Jackson Township

Zoning Commission

Rezoning **2-RZ-2024**
Applicant: Spartak Selmiaj
Property: 1696 Dyer Road, (parcel #160-000860)
Acreage: 10.05 acres
Utilities: Onsite Well and septic
Request: To amend Exceptional Use District

Concept Site Plan

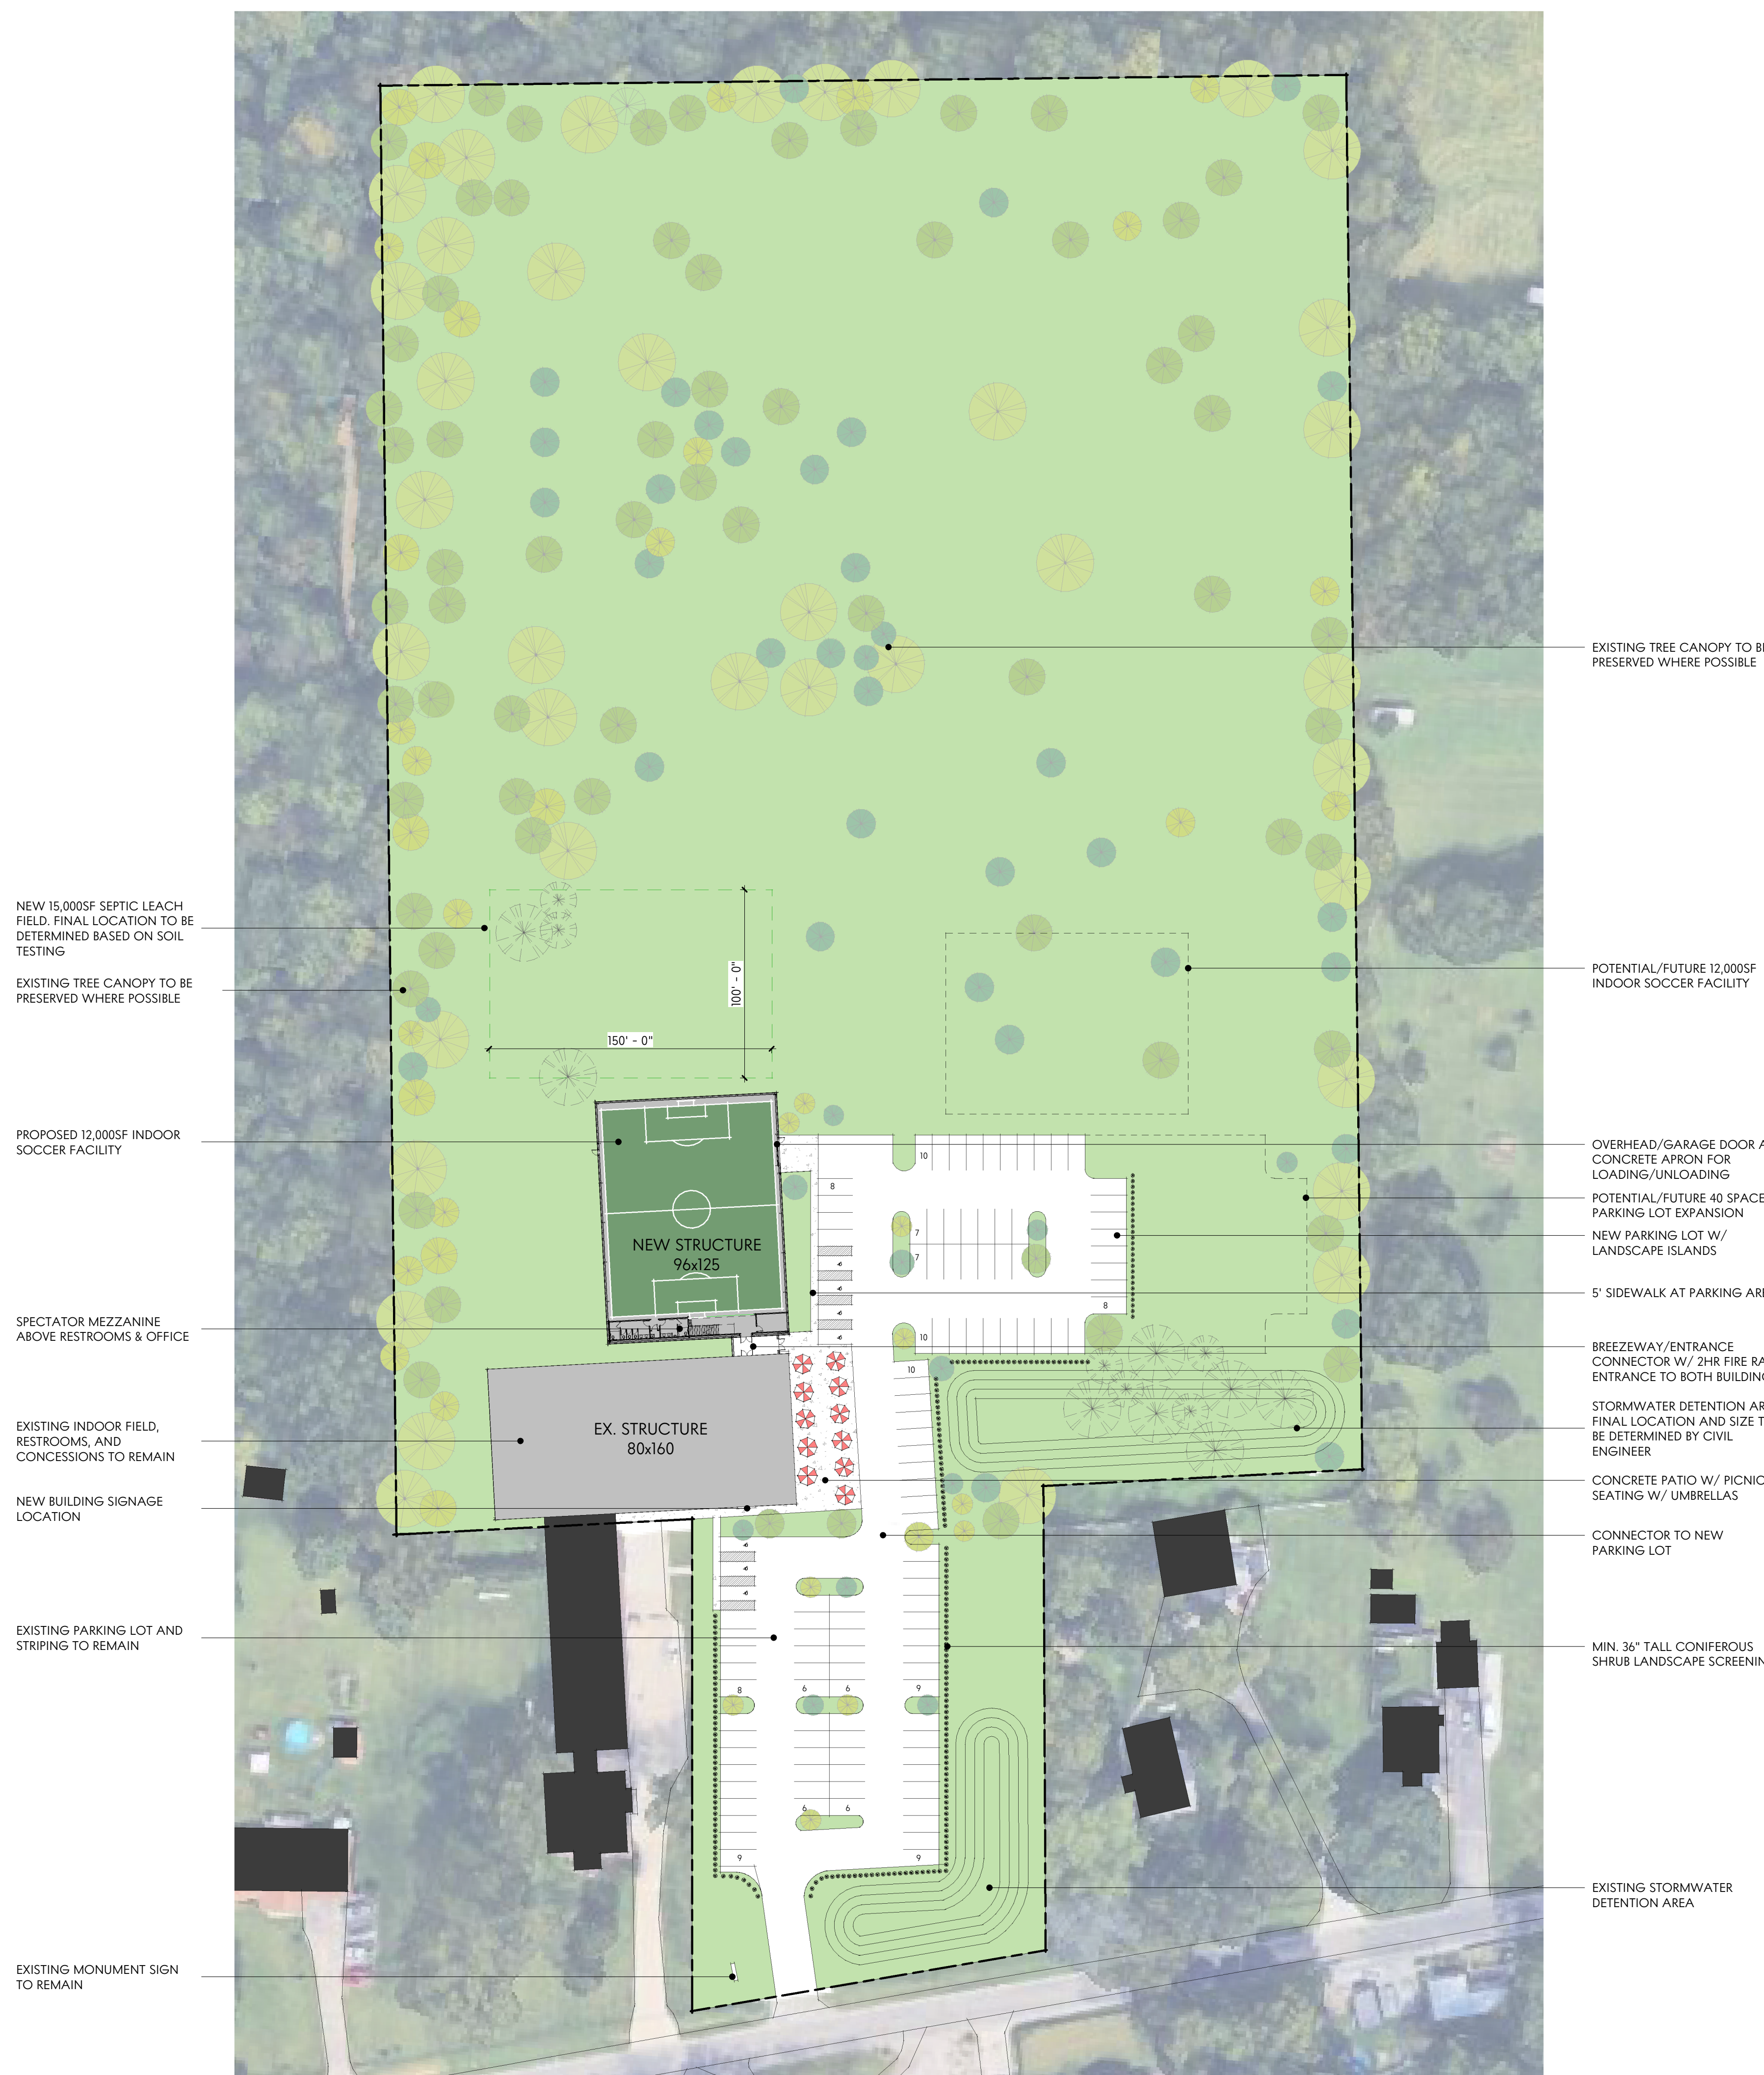
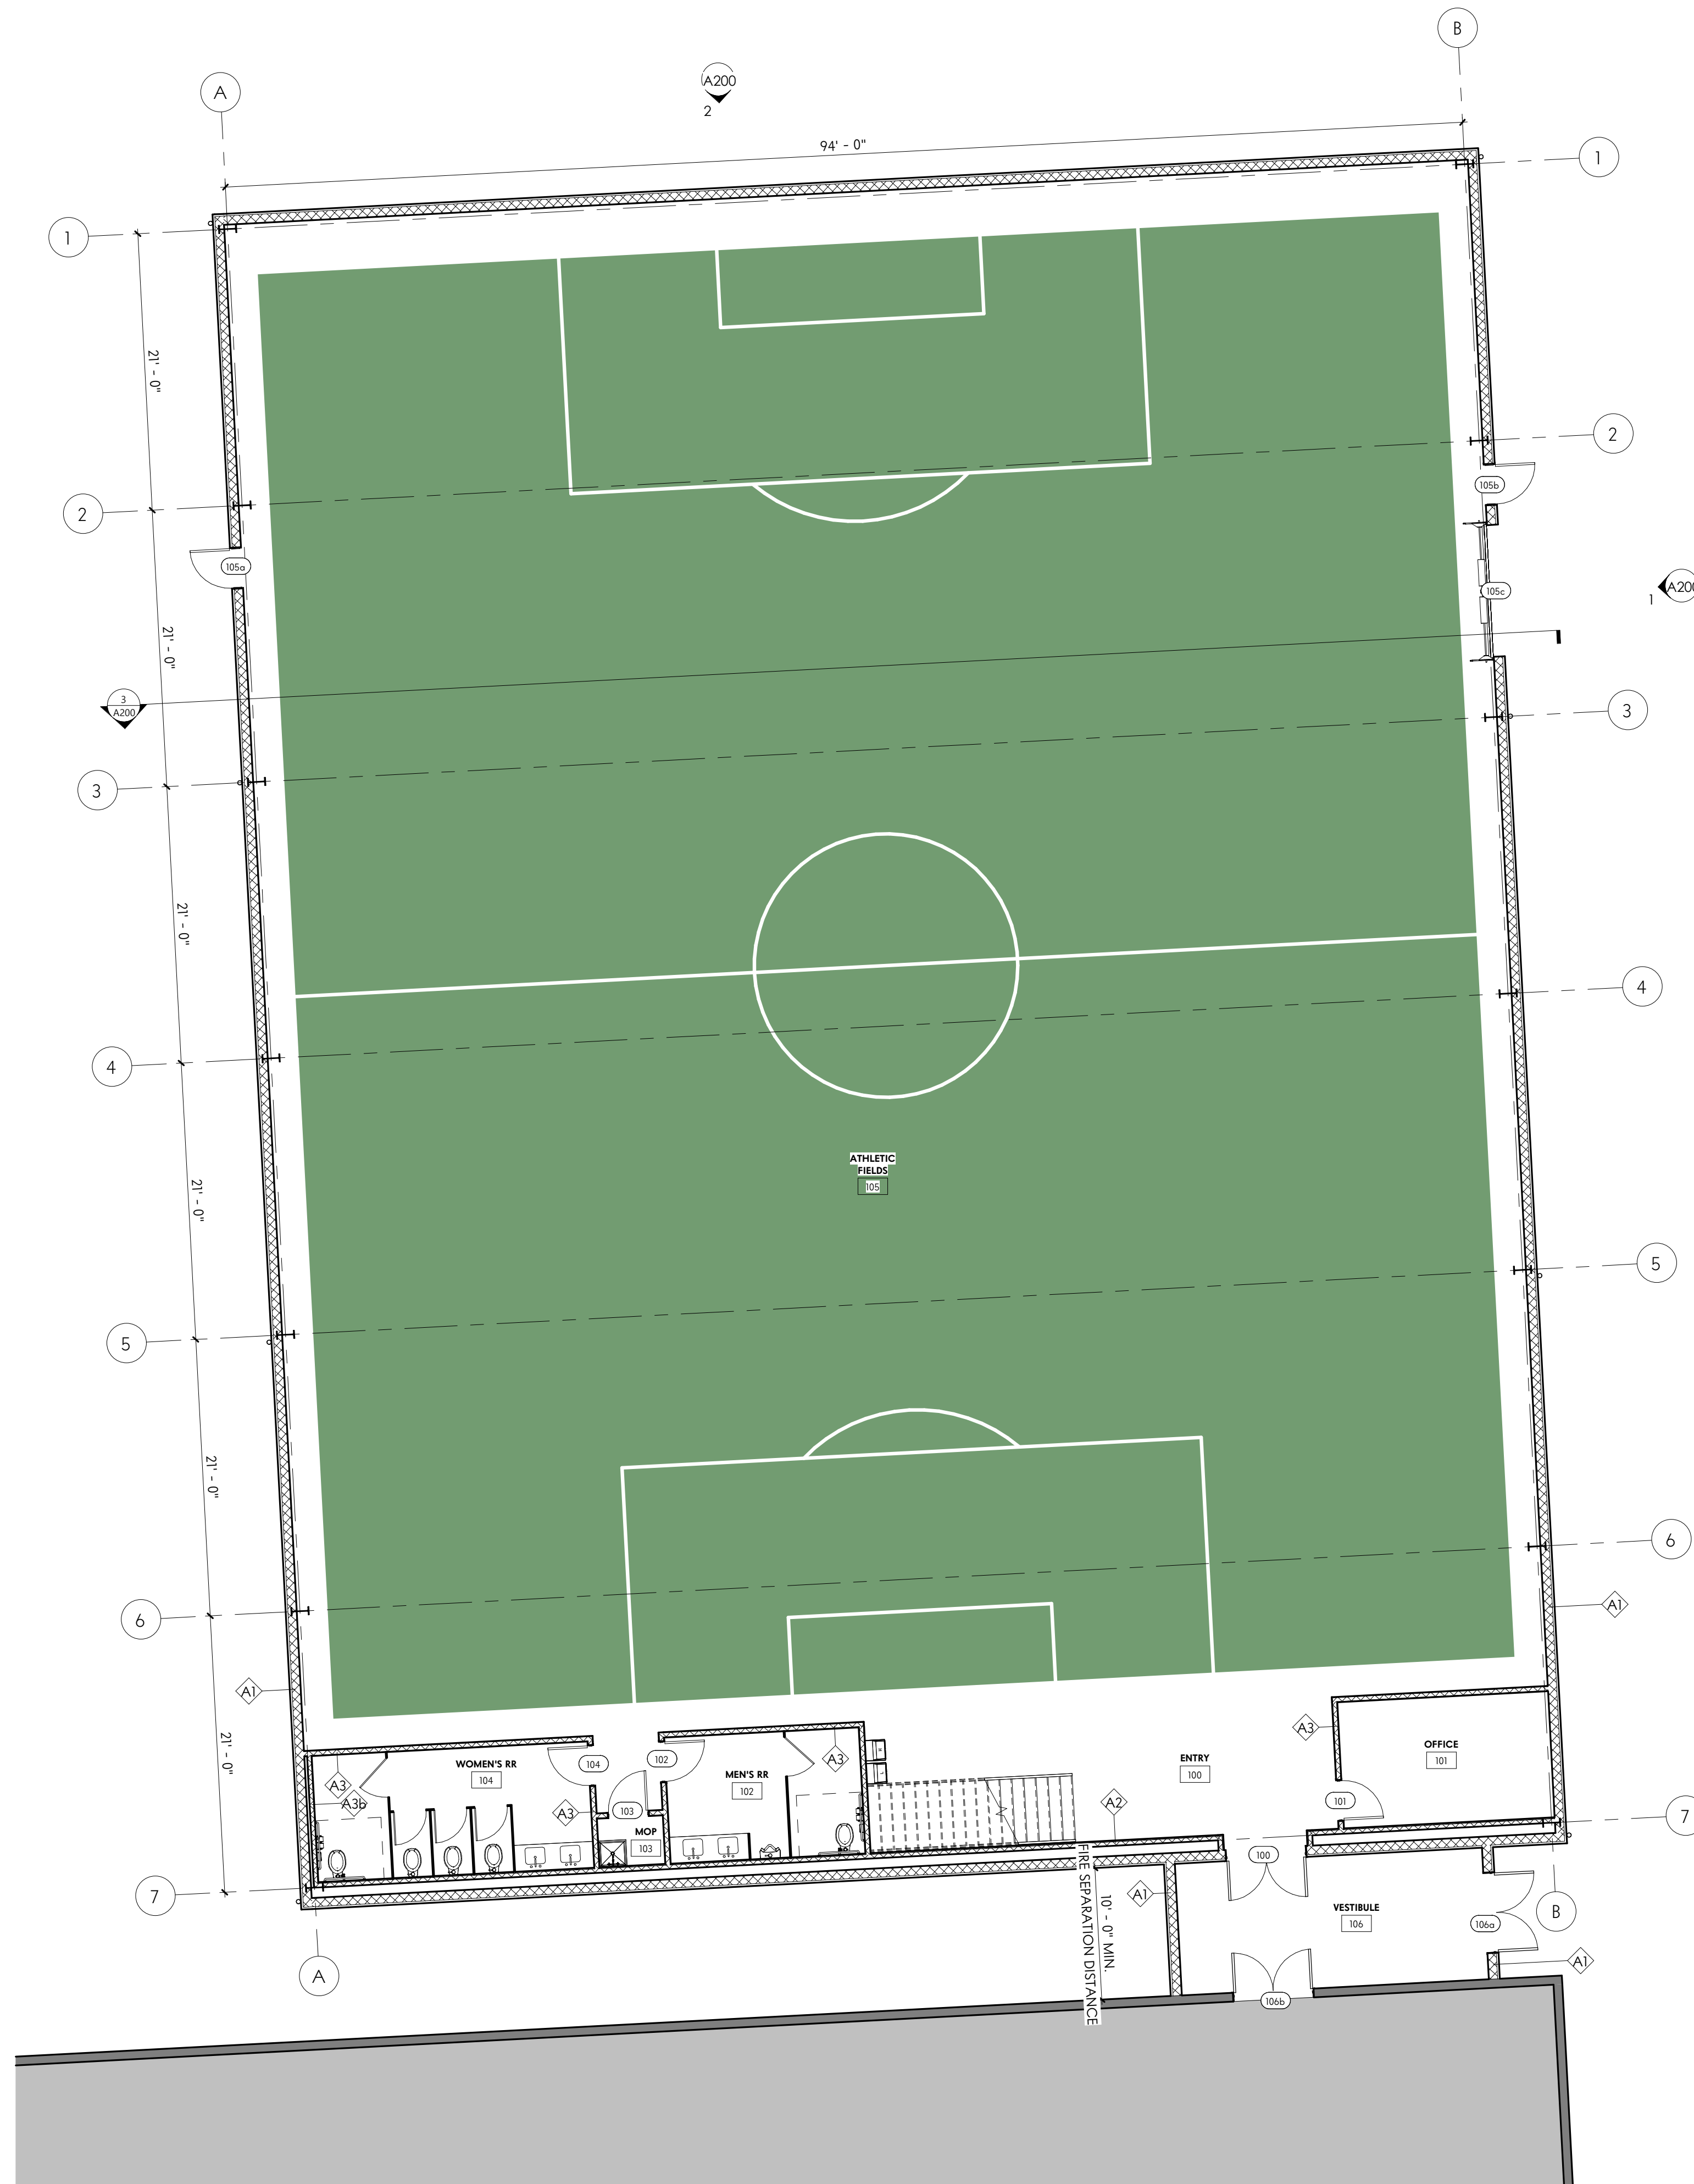
The submission lacks the development text and related detail in the development plan identifying the full extent of development associated with the proposed change of use. Details on lighting, landscaping, trash collection facilities, and utilities are missing. The development plan does not meet the standard dimensions for parking spaces dimension or internal parking lot landscaping requirements. Also, staff has concerns regarding potential negative light, noise, and traffic impacts to the surrounding properties. Furthermore, the submission did not address traffic, stormwater and noise impacts, or detail hours of operations.

1. The proposed location and size of areas of use, indicating size, location and type of structure.
 - a. *The revised development plan includes details of two proposed structures. Both proposed structures are 12,000 square feet (96' x 125'). The existing 12,800 square foot (80' x 160') structure is proposed to continue to be used for indoor sporting activities.*

- a. *The revised development plan removes the outdoor athletic fields.*
 - b. *The existing tree canopy to be preserved where possible.*
 - c. *36" tall coniferous shrubs are proposed along the perimeter of the existing and proposed parking areas.*

- c. *Stormwater is to be managed by an on-site detention pond which will require compliance with the Franklin County Stormwater Drainage Manual.*
 - i. *The development proposes a second Stormwater detention area to the north and east of the existing detention basin. It is unclear if both detention basins will be tied into each other or will have separate outlets.*

- b. *Jackson Township Planning Department will confirm required parking is provided through their zoning compliance review. The required number of spaces have been provided on the plan; however, the spaces do not meet the minimum dimensional Township requirements of 10 ft. by 20 ft.*

- a. *No development text has been provided to elaborate on the proposed rezoning and development. A development plan showing the location of the proposed indoor facilities has been included in submitted material. A schedule on the proposed development at the site, stormwater drainage plans, access impact study, or landscaping plans has not been provided.*

1. Provide a detailed development text prior to Township Trustee public hearing.
2. Provide a detailed buffering and screening along adjacent residential properties.
3. Provide proposal to minimize traffic headlight impact to 1695 Dyer Road.
4. Items prior to Zoning Compliance Certificate:
 - a. Stormwater management details and calculations are submitted to and approved by the Franklin County Engineer.
 - b. A completed traffic impact analysis is submitted to and approved by the Franklin County Engineer.
